**SEQUOYAH FUELS CORPORATION
RESPONSE TO REQUEST FOR
ADDITIONAL INFORMATION
GROUND WATER CORRECTIVE
ACTION PLAN REVIEW**

Subject: Sequoyah Fuels Corporation, Docket – 40-8027
Request for Additional Information – Groundwater Corrective
Action Plan (TAC L52528)

Responses to NRC RAIs of September 28, 2005
Ground Water CAP Review

FIGURE 8-32
ONE DIMENSIONAL TRANSPORT ANALYSIS, 2322A

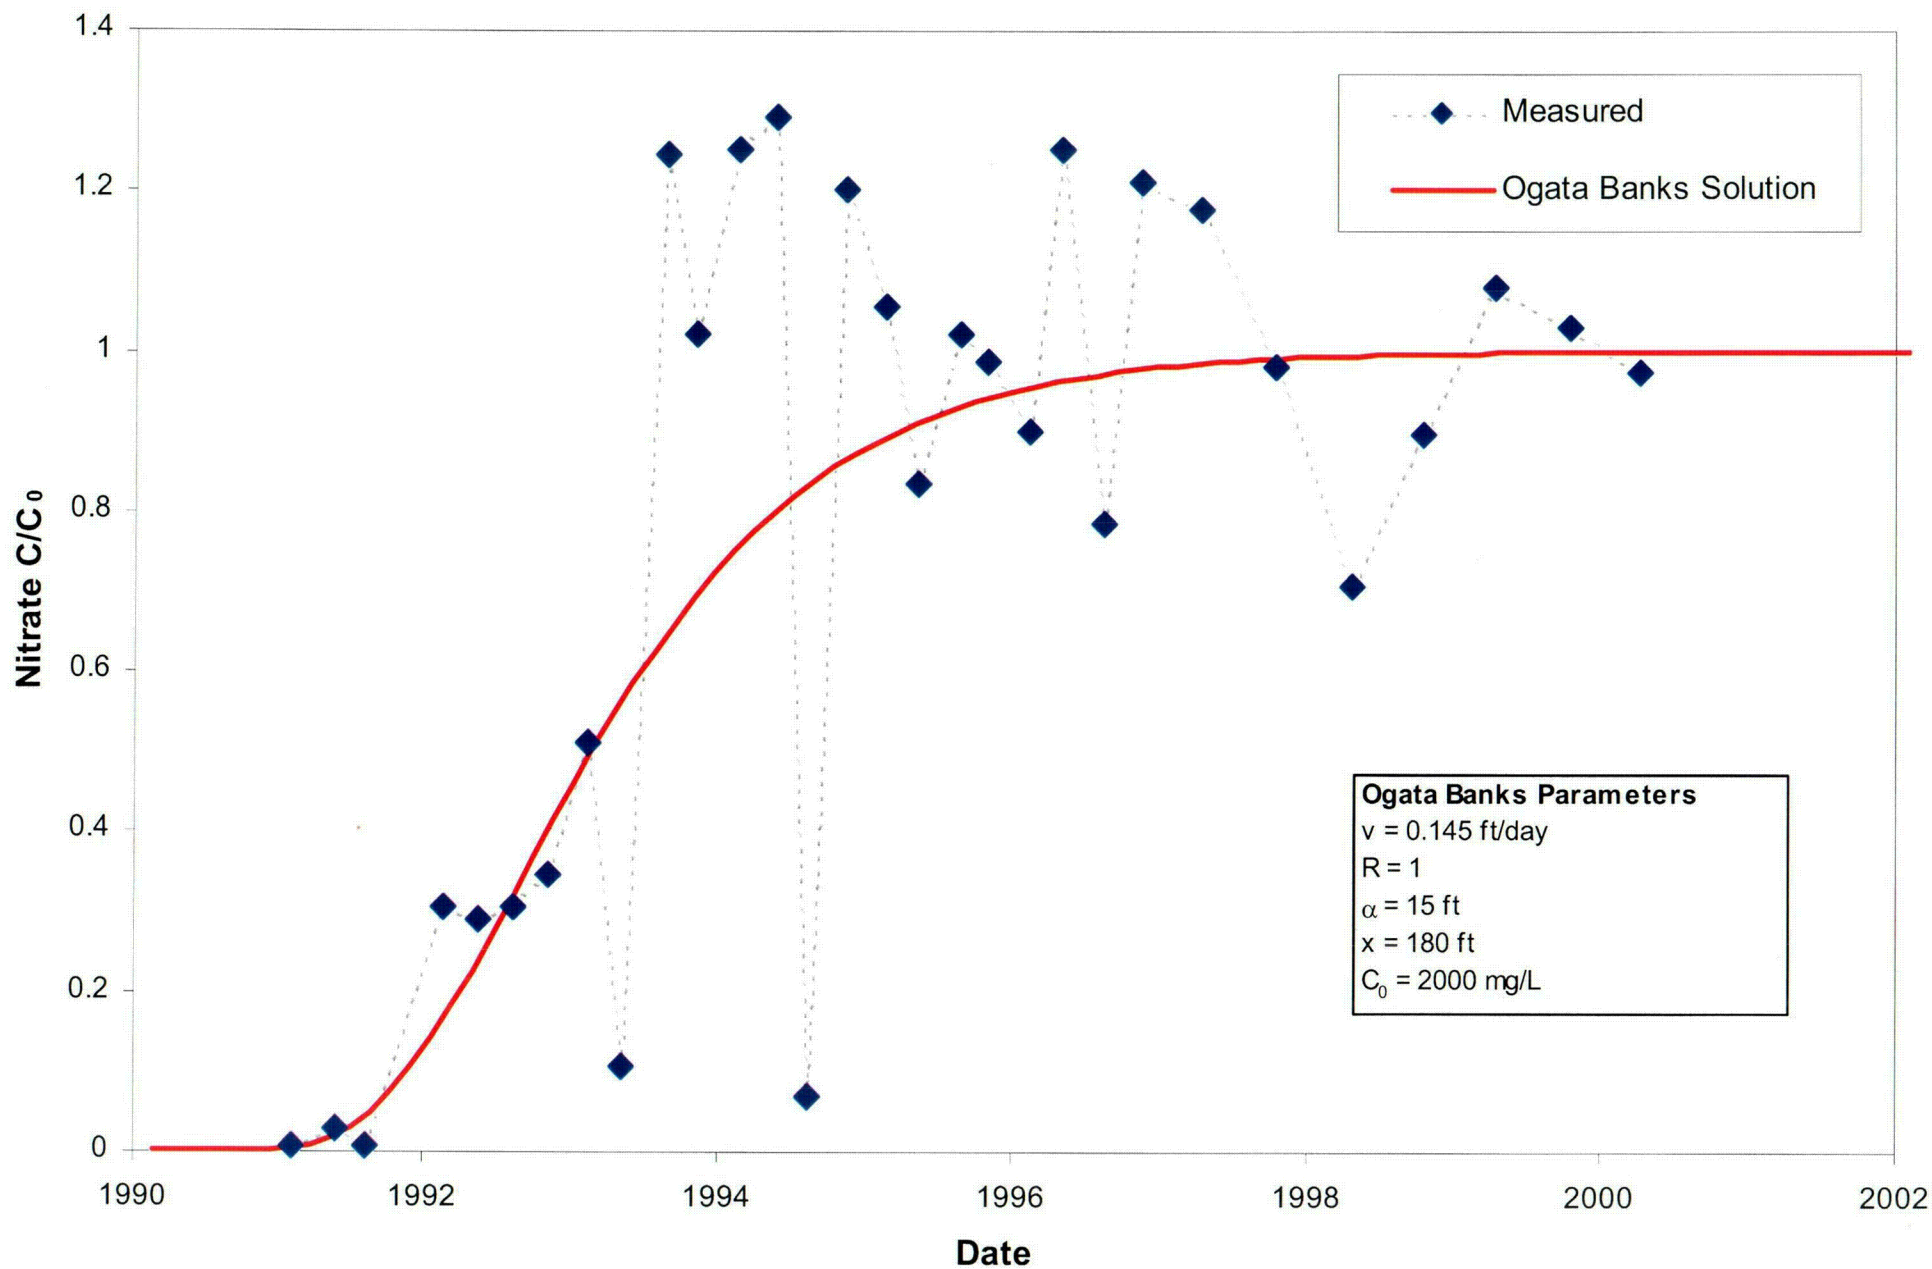
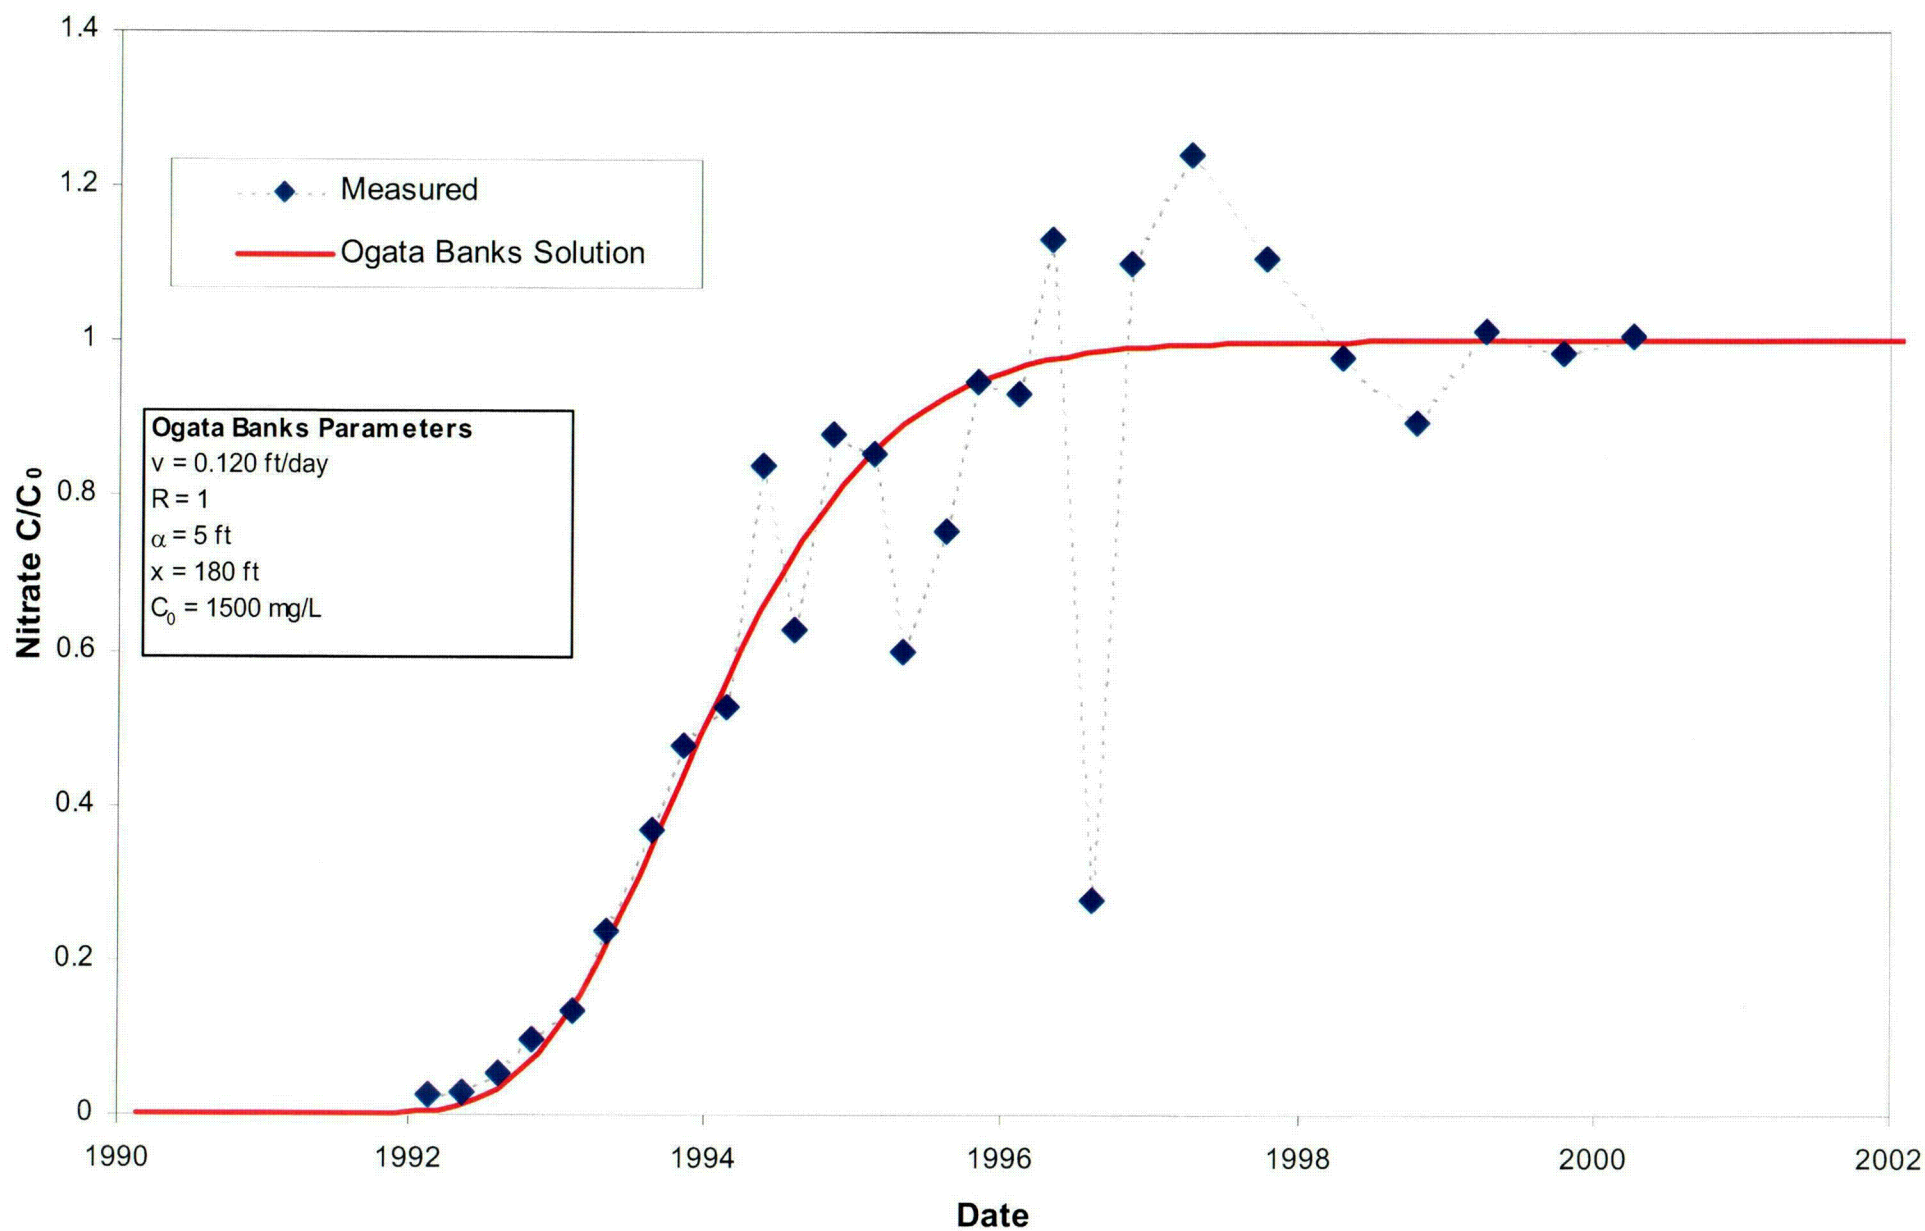
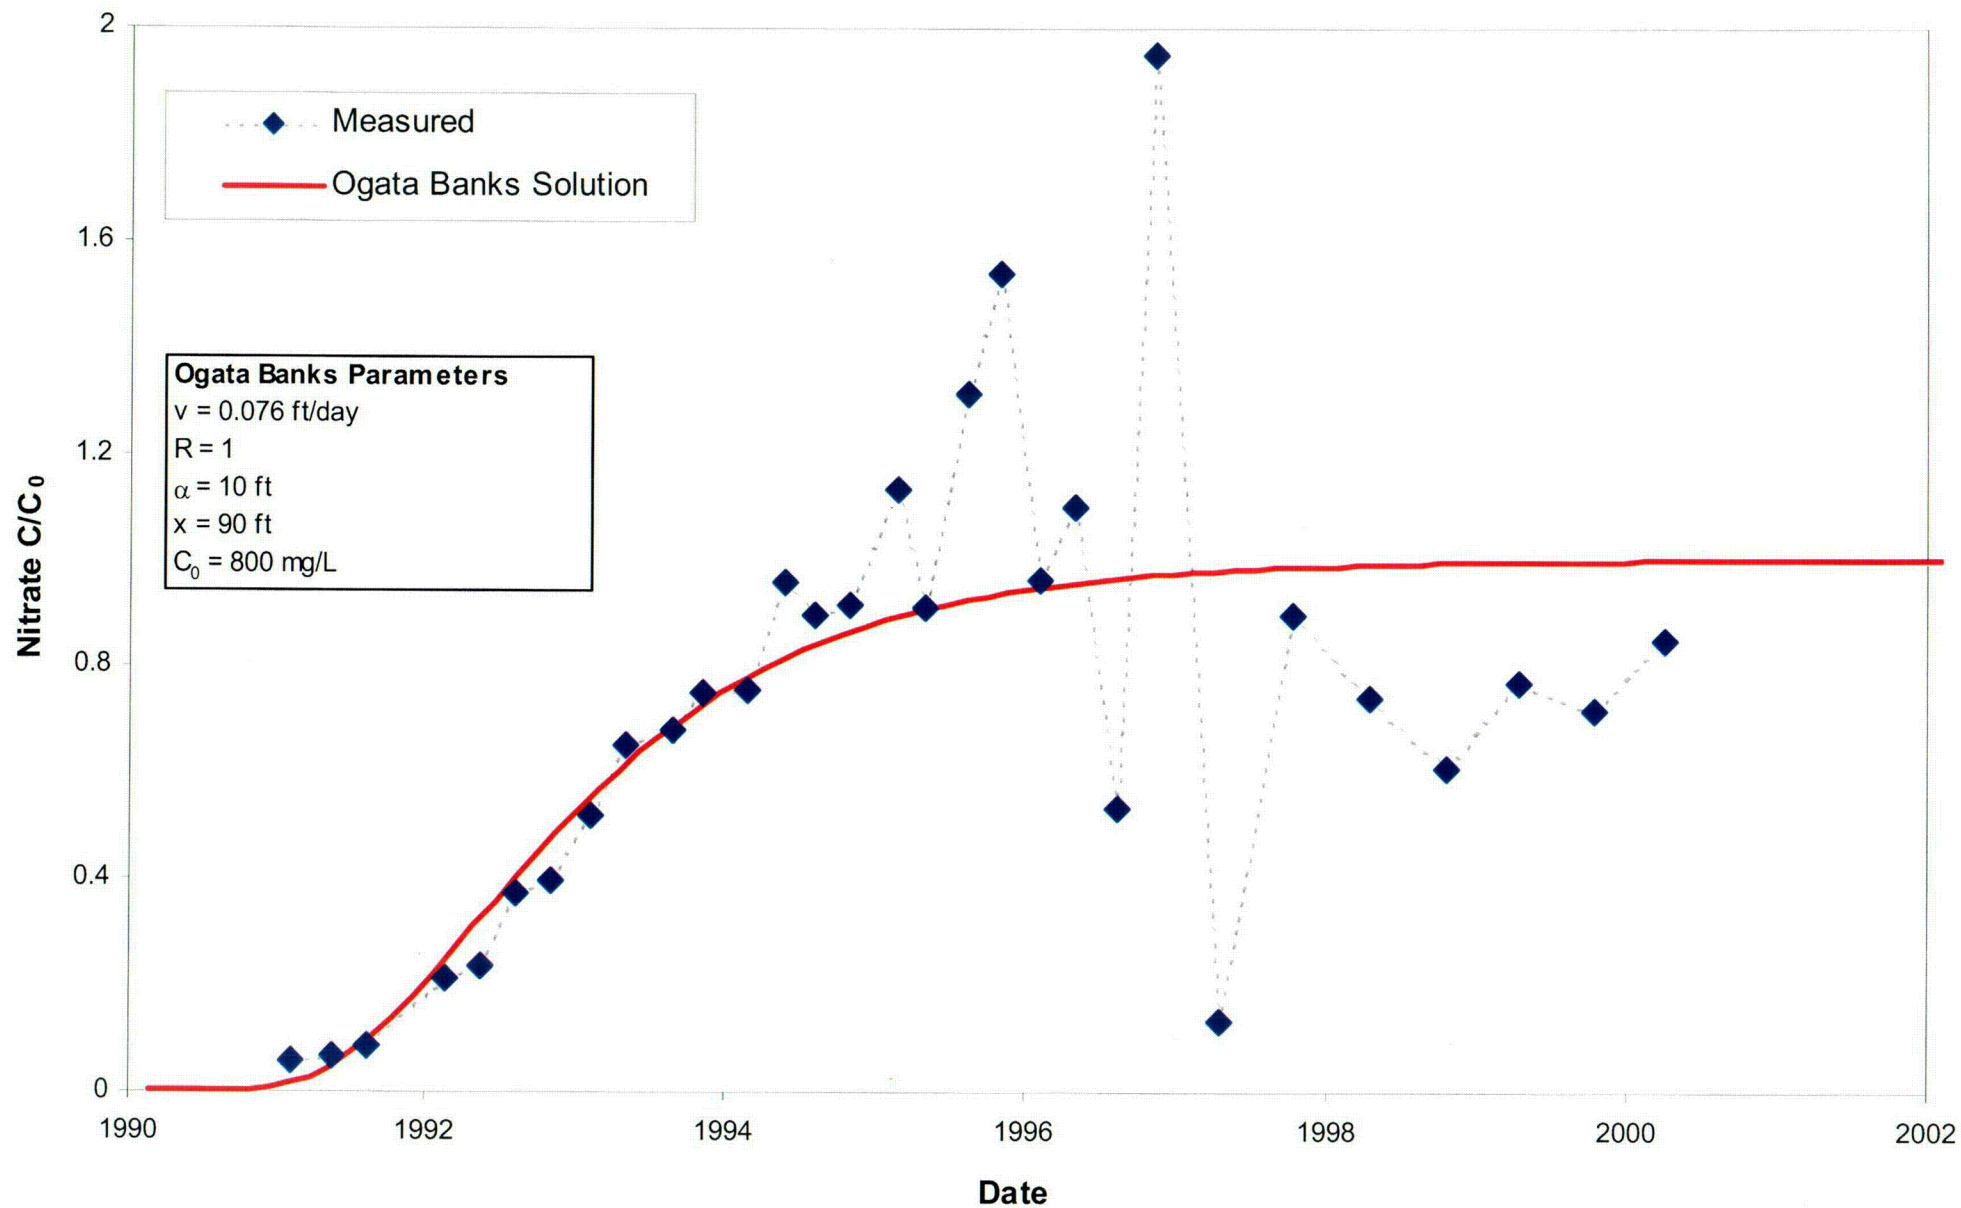
- E. The CAP should include more information regarding contaminant transport, such as dispersivity (longitudinal, vertical, horizontal), retardation factors, and areal recharge rates. Discussions of the geochemical investigations and attenuation mechanisms should also be included in the CAP. SFC should present the most recently estimated values. This information is necessary for evaluating whether the contaminants at SFC would be amenable to the type of remedial actions proposed by SFC.

The longitudinal dispersivity in all layers was initially estimated based on an empirical, scale dependent equation from Xu and Eckstien (1995). The transverse dispersivity and vertical dispersivity were estimated to 10 percent and 1 percent of the longitudinal dispersivity, respectively (Fetter, 1999). Estimated values of longitudinal, transverse, and vertical dispersivity using Xu and Eckstien are 50 feet, 5 feet, and 0.5 feet, respectively. Longitudinal dispersivity values were further evaluated using the Ogata-Banks advection dispersion equation (ADE) solution (HGSCR, Section 8.5.3) and were found to range from 1 foot to 20 feet as illustrated in HGSCR Figures 8-32 through 8-36 (dispersivity = α , Attachment CAP2E-1).
